Subject: Imperial Valley Solar (formerly Solar Two 08-AFC-5)
Errata Sheets for the Juan Bautista de Anza National Historic Trail
Visual Impact Analysis
URS Project No. 27657103.00200

On behalf of Imperial Valley Solar Two, LLC, URS Corporation Americas (URS) hereby submits the Errata Sheets for Juan Bautista de Anza National Historic Trail Visual Impact Analysis (VIA). These errata sheets revise language in the original report referring to the Anza Monument to correctly refer to the Yuha Geoglyph Monument.

**GTTCVC"UJ GGVU"HQT"SES SOLAR TWO -
ANZA TRAIL VISUAL IMPACT ANALYSIS**

**EXISTING VIEW OF PROJECT FROM KOP #2
SOLAR TWO – DE ANZA TRAIL VIA**

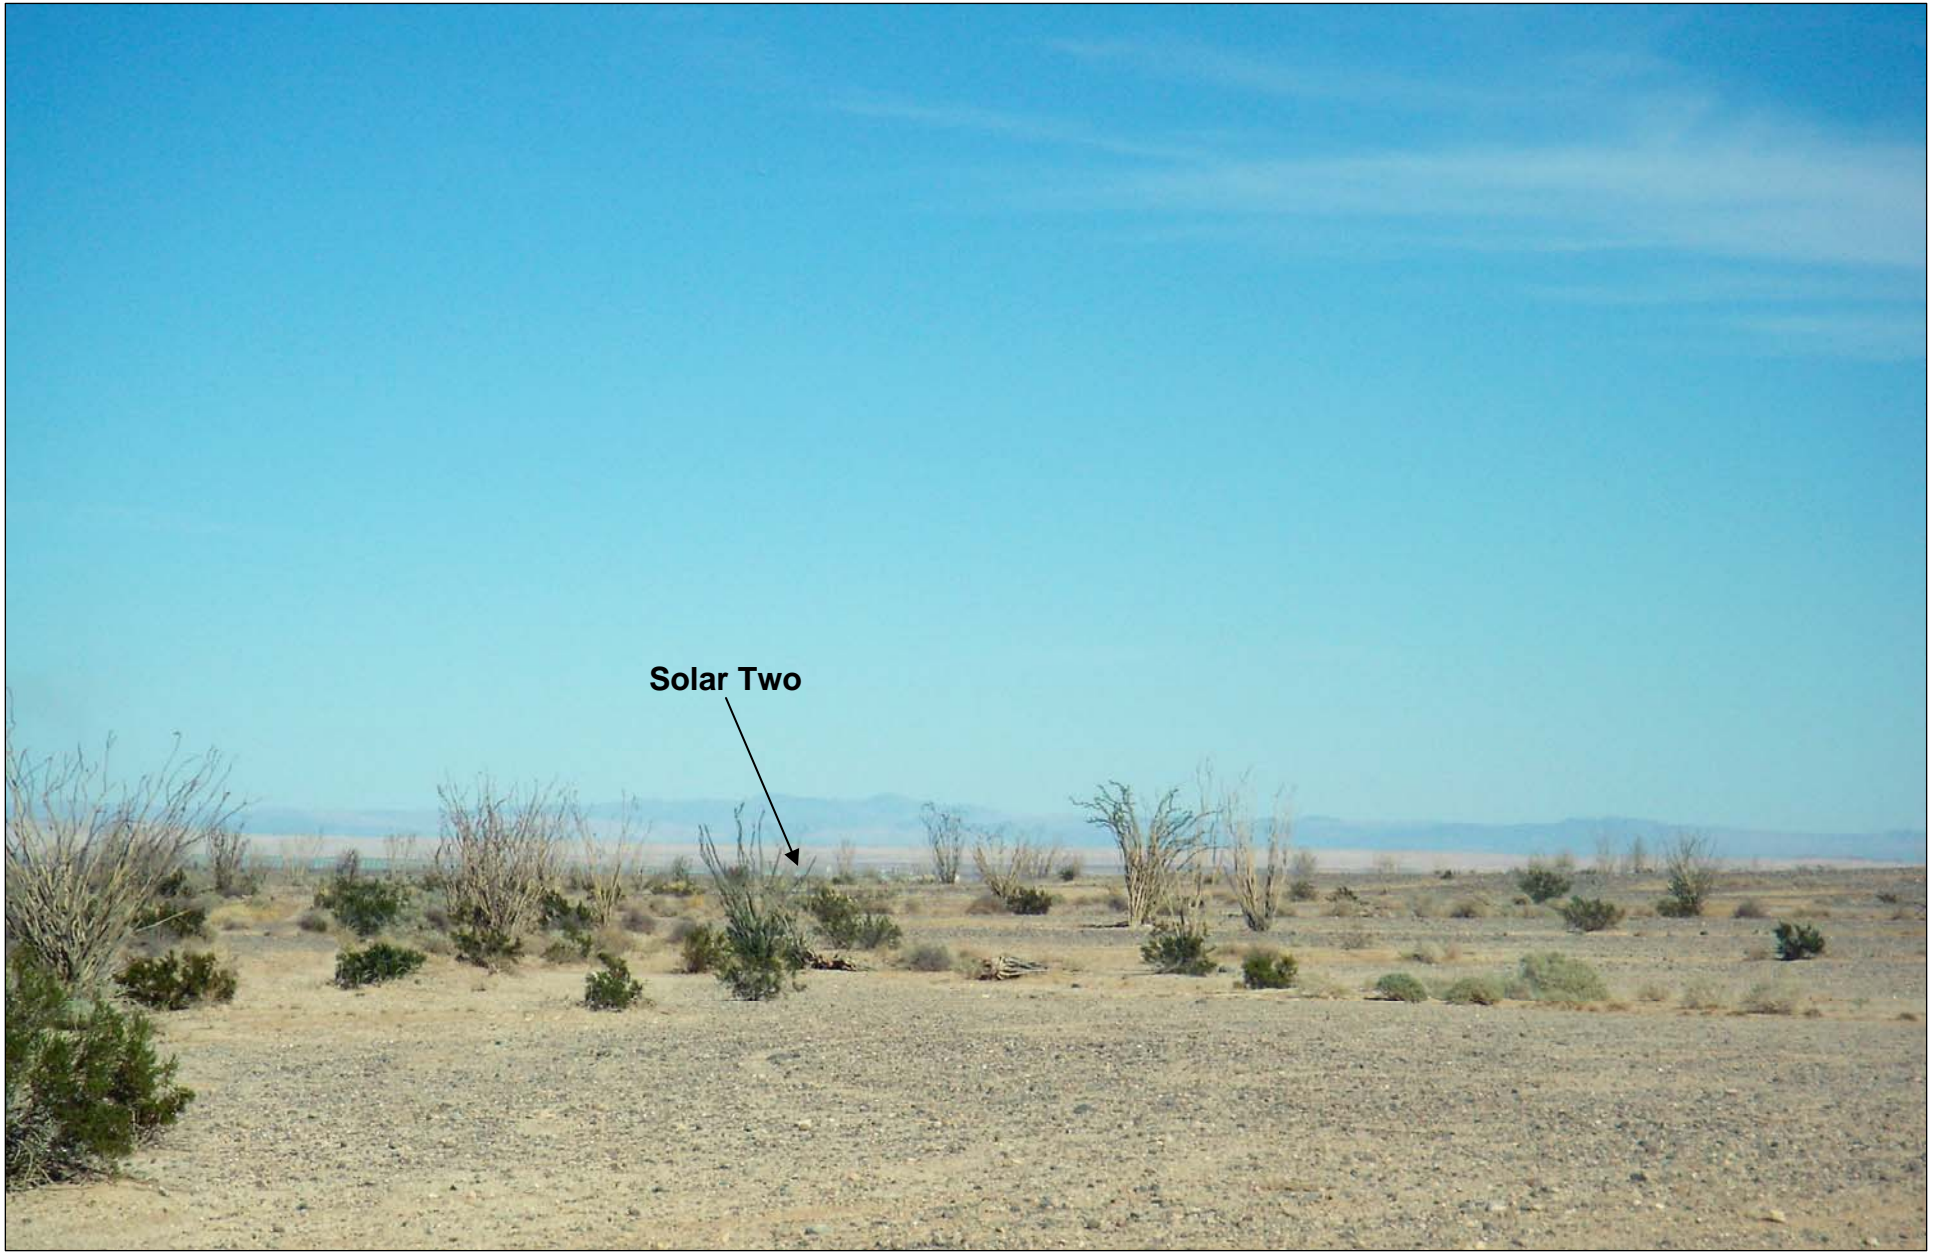
KOP 2: Existing view from Yuha Geoglyph Monument along De Anza Trail (approximately 2.5 miles south of Project).
